Technical Review Committee Agenda

**CITY OF DELAND
THURSDAY MAY 16, 2024 AT 1:30 P.M.
CITY OF DELAND TRC MEETING ROOM
DELAND, FLORIDA**

City of DeLand
Z24-030
CLOISTERS
PD AMENDMENT

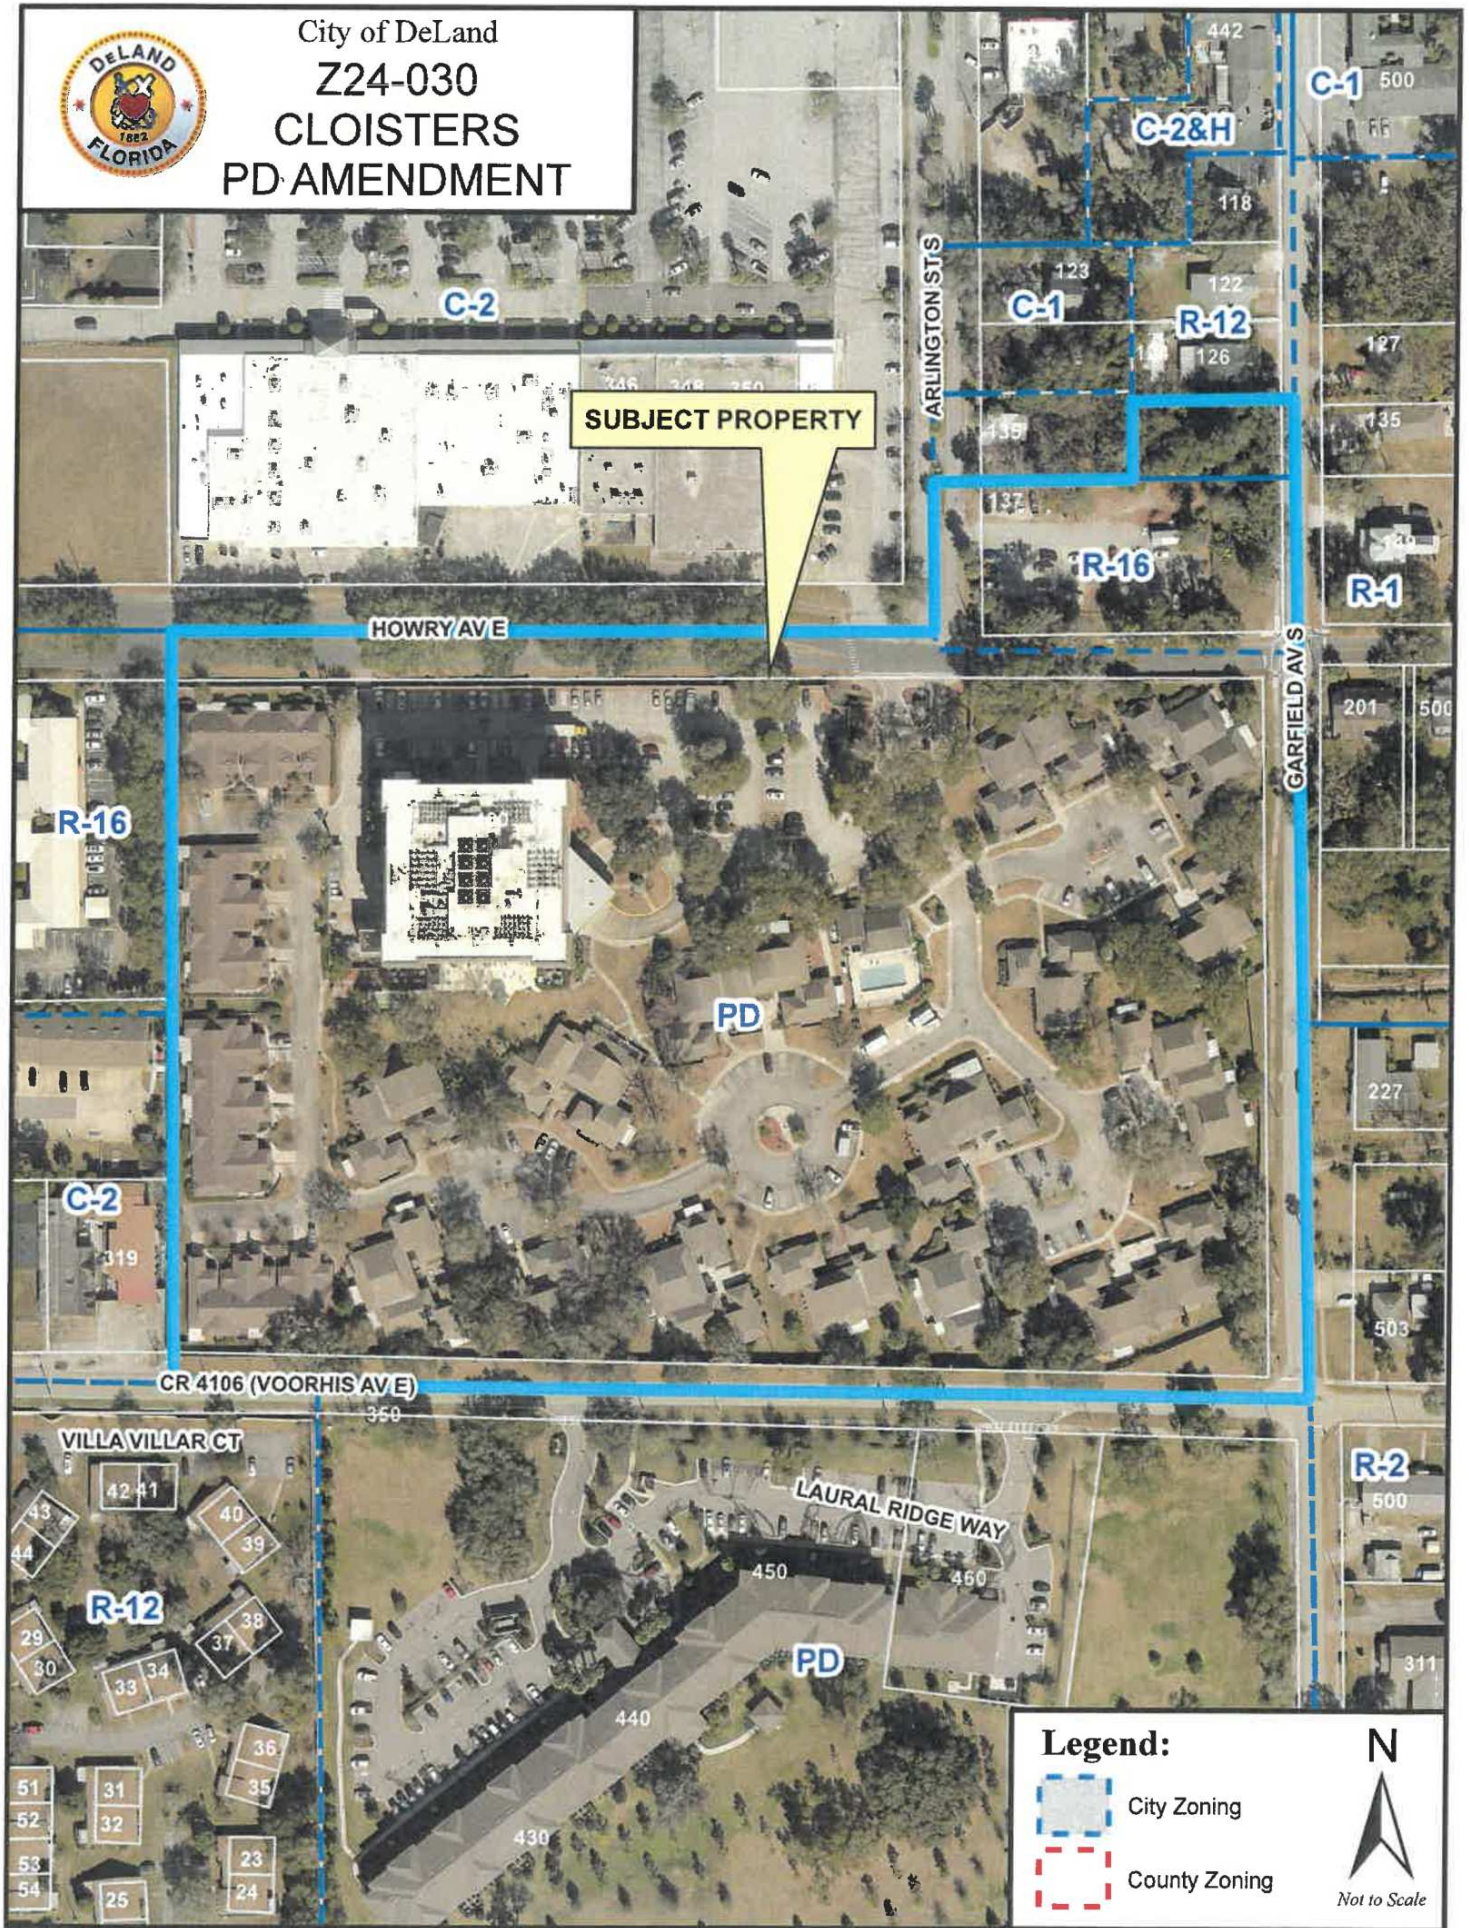
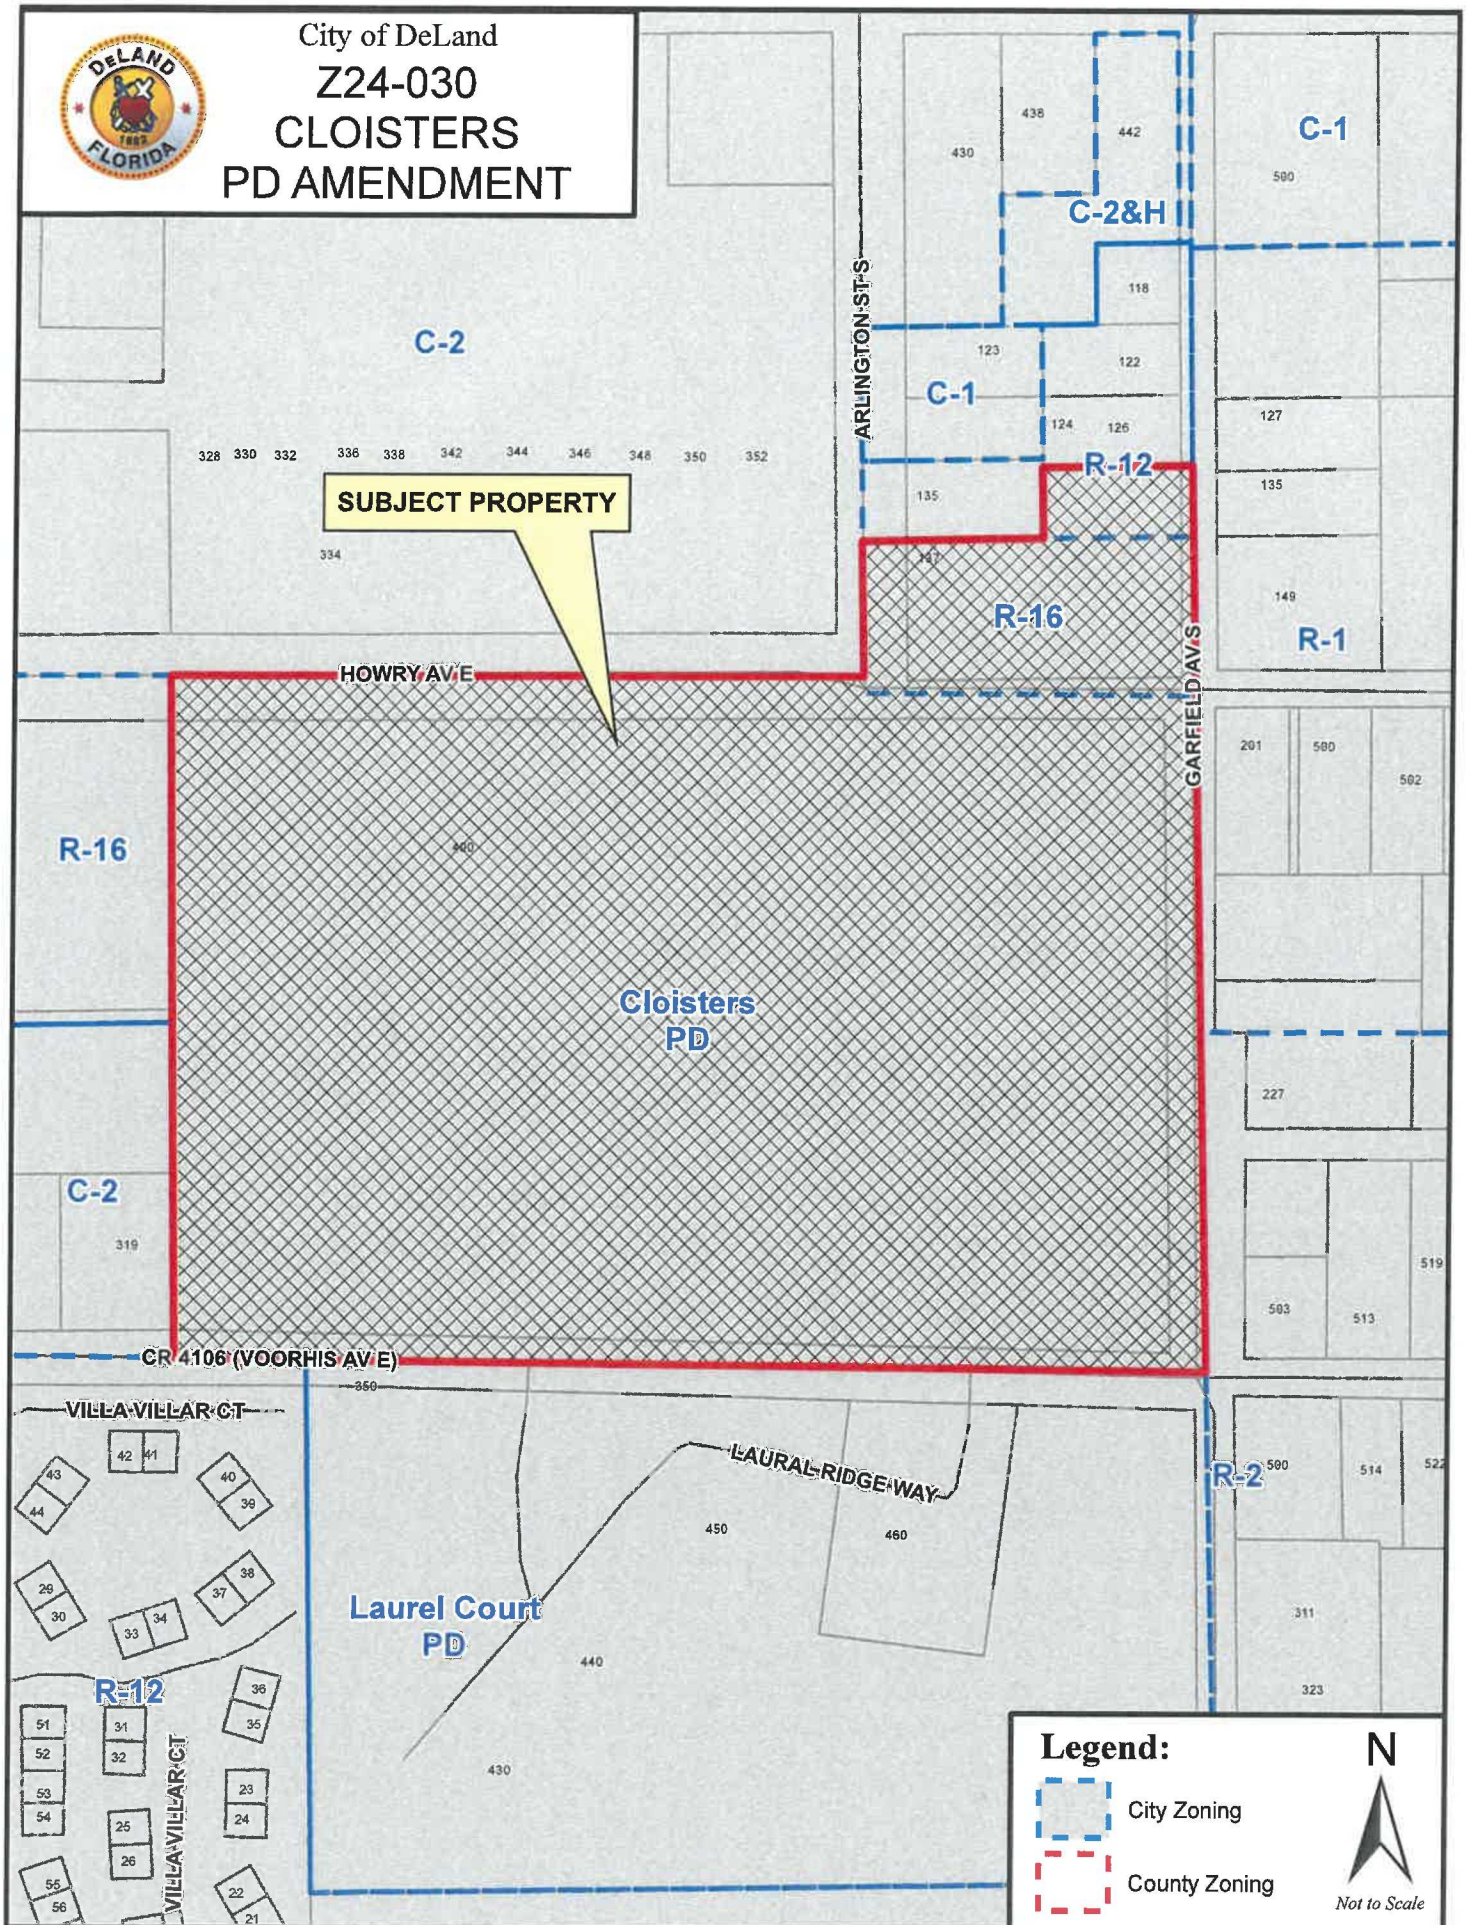
Discipline	Status	Details	Attached To	Created By	Last Updated By	Modifications Required
Forestry	Draft	Tree Protection Area 15% of the site will need to be reserved for Tree Protection Area. The Minimum width for TPA's is 30' where existing trees are to be preserved, and 20' where the TPA will consist of newly planted trees.	Cloisters - Concept Parking Layout.pdf	Kit Dennis	Kit Dennis	Yes
Forestry	Draft	Tree/Landscape Requirements It should be added to the PD that the new parking lot parcel will need to meet the tree protection and coverage requirements stated in the current Land Development Regulations. (Ord. No. 2013-11)	Cloisters - Parking Layout.pdf	Kit Dennis	Kit Dennis	Yes
Planning	Draft	Villa parking Verify that the parking spaces located in the Villas are for the exclusive use of those residents and not available for the other residents.		Belinda Collins	Belinda Collins	Yes
Planning	Draft	Attachment A Verify what Attachment A is as described in Item 3 of the PD amendment.		Belinda Collins	Belinda Collins	Yes

Planning	Draft	Parking spaces Verify that Exhibit B accurately reflects the number of parking spaces in each Tract. Tract 1 appears to not total 96 spaces.		Belinda Collins	Belinda Collins	Yes
Planning	Draft	Parking study A parking study may be required if further parking reduction is needed. Provide clarification regarding existing conditions at the site. Additional information is needed regarding the number of villas and the number of parking spaces provided for the villas. Clearly identify the number of 1 and 2 bedroom units in the 15 individual apartment buildings and verify the parking information for each of them as well.		Belinda Collins	Belinda Collins	Yes
Planning	Draft	Units Verify the breakdown of unit types and their locations: 272 units total = (1 tower - ____ units, 4 villas - ____ units, 15 bungalows - ____ units)		Belinda Collins	Belinda Collins	Yes

Discipline	Status	Details	Attached To	Created By	Last Updated By	Modifications Required
Planning	Draft	School concurrency Because this site will be opened up to the general population, a review of school concurrency impacts is needed. Submit an application to the Volusia County School Board to determine impacts to nearby schools: https://www.vcsedu.org/fs/resource-manager/view/5d40622d-ada4-4e00-acd1-43d36670a2a4		Belinda Collins	Belinda Collins	Yes
Utilities	Draft	Utilities Capacity Did anyone compare the utility demand if additional personnel loading is allowed? Water lines and sewer adequate to handle interior loadings?	Cloisters - Concept Parking Layout.pdf	Jim Ailes	Jim Ailes	Yes
